4-Way Commercial Phase 1
Site Development Plan
Traffic Impact Analysis
PCD File No. PPR2347
(LSC #S224452)
January 27, 2026

6/17/2026
LSC Responses
to EPC TIS Redline
Comments

Exhibit 2
Dumont Drive Proposed Future Laneage
4-Way Ranch Commercial Phase 1 (LSC #5224452)

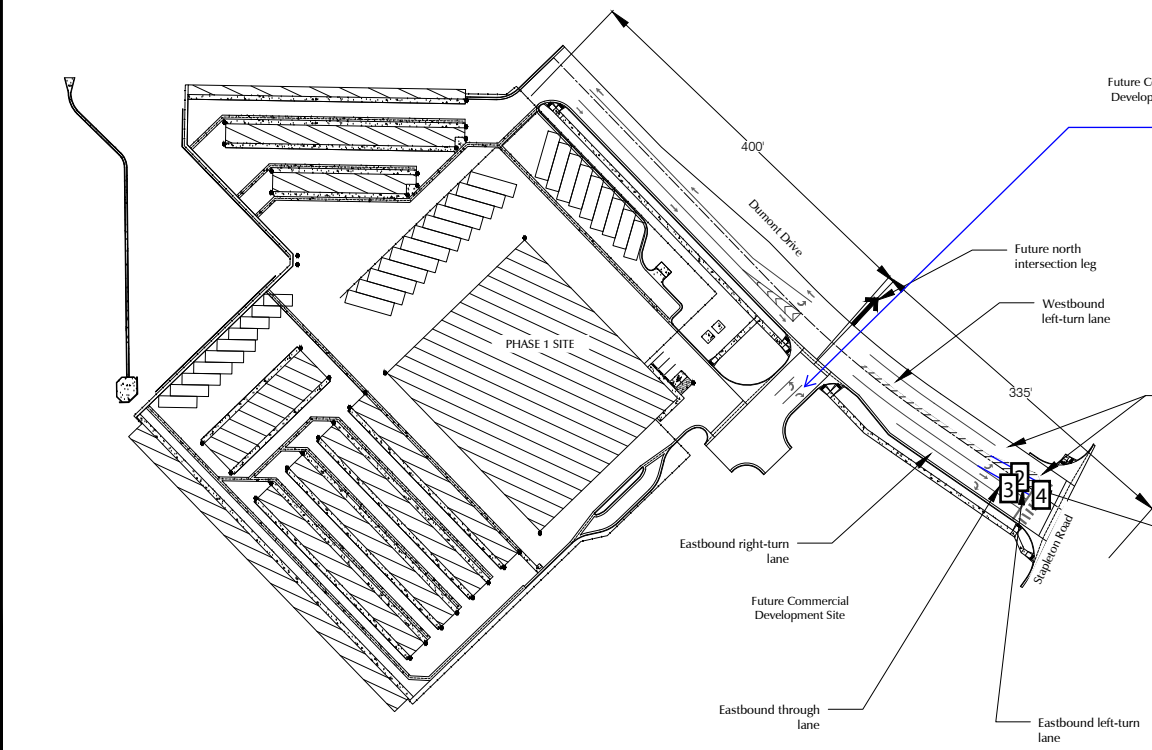
[see comments regarding these access points and revise the study accordingly](#)

1. See comments in the narrative regarding this access. A deviation would not be supported as there is too many unknowns at this stage. Additionally, a northern leg at this location would further cause traffic operations issues. Although the access can be allowed in the interim, future development/subdivision would necessitate the relocation/removal of the access.

see comments in the narrative regarding this access. A deviation would not be supported as there is too many unknowns at this stage. Additionally, a northern leg at this location would further cause traffic operations issues. Although the access can be allowed in the interim, future development/subdivision would necessitate the relocation/removal of the access.

LSC Response: A second scenario assuming no right-in/right-out access points has been added to the TIA.

LSC Response: The report narrative has been revised and a new section has been added to the TIS. Also note: LSC and the owner recently met with Mr. Torres to discuss our suggested language for conditions of approval, for staff consideration.

Also, the TIS has been updated to show the future north-side access point to Dumont shifted 150' to the southwest (offset from the east SDP access point).
